# Product Change Notification

## 113610 - 00

**Change Notification #:** 113610 - 00  
**Change Title:** Intel® Server System R2208GZ4GC  
PCN 113610-00, Product Design  
Update System Rear Panel, 750W Common  
Redundant Power Supply and  
BIOS/ME/BMC/FRUSDR Firmware  
**Date of Publication:** January 27, 2015

Figure One

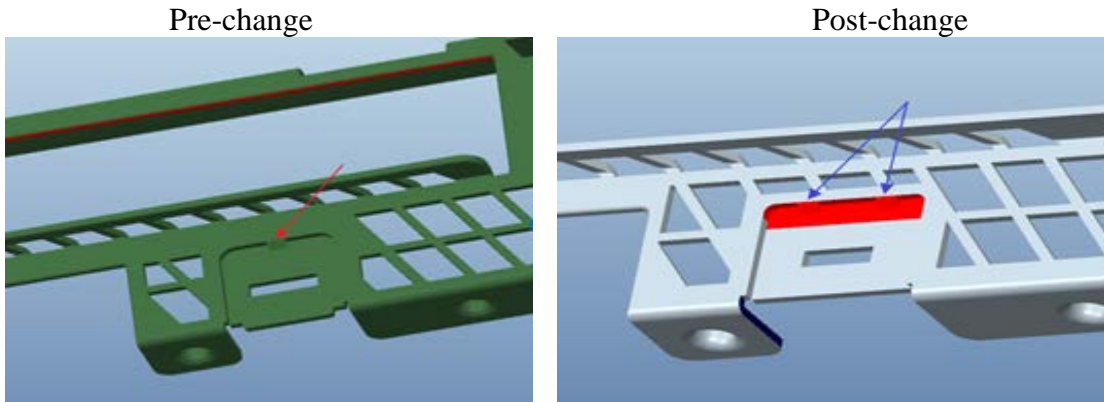
1. The Intel® Server Board S2600GZ Printed Board Assembly (PBA) revision has been updated from G11481-352 to G11481-355 with the following changes:
  - Update the BIOS from revision 01.02.0005 to 02.03.0003.
  - Update the Integrated Baseboard Management Controller (BMC) firmware from revision 01.00.0026 to 01.21.6580.
  - Update the Manageability Engine (ME) firmware from revision 02.01.05.091 to 02.01.07.328.
  - Update the FRUSDR from revision 1.03 to 1.13.The system software update package, including the release notes for each, is available for downloading from <http://www.intel.com/support>. Please refer to the software release notes for a list of changes.
2. Update the one big center joint to two smaller joints so that the joints will not conflict with the LAN cable connector latch. See Figure One.

Figure Two

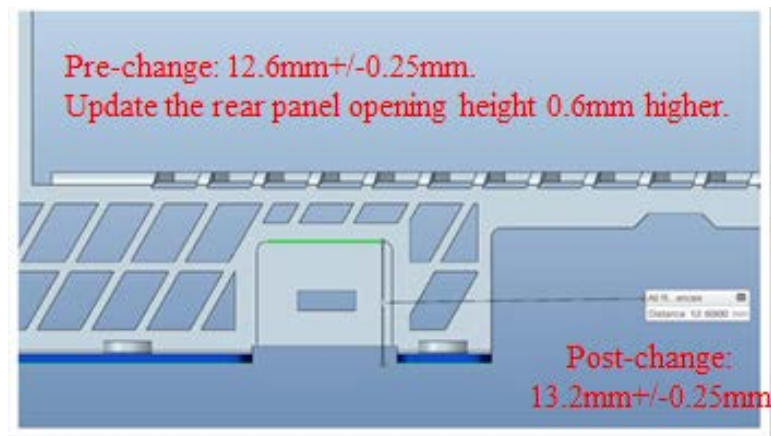
3. Update the rear panel opening height 0.6mm higher to improve the flexibility for the cable latch. The previous height was 12.6mm $\pm$ 0.25mm. The updated height is 13.2mm $\pm$ 0.25mm. See Figure Two.

Figure Three

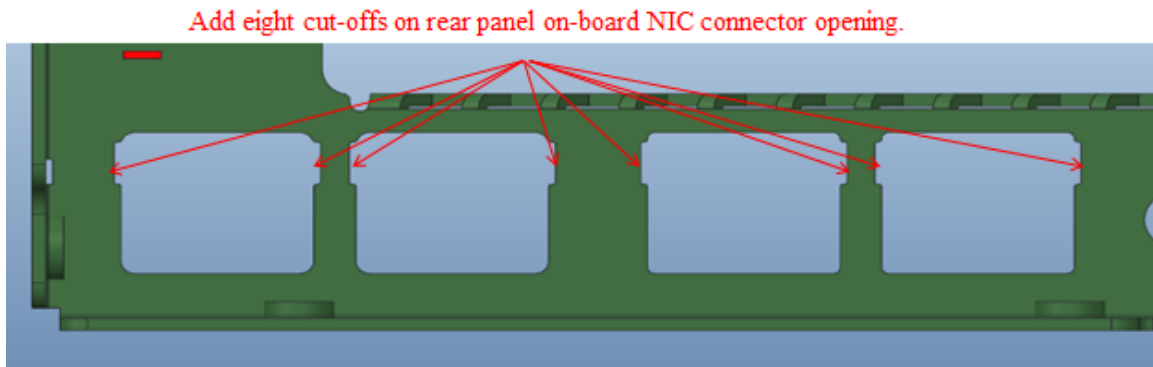
4. Add eight cut-offs around the on-board NIC (Network Interface Controller) openings to improve the LED visibility. See Figure Three.
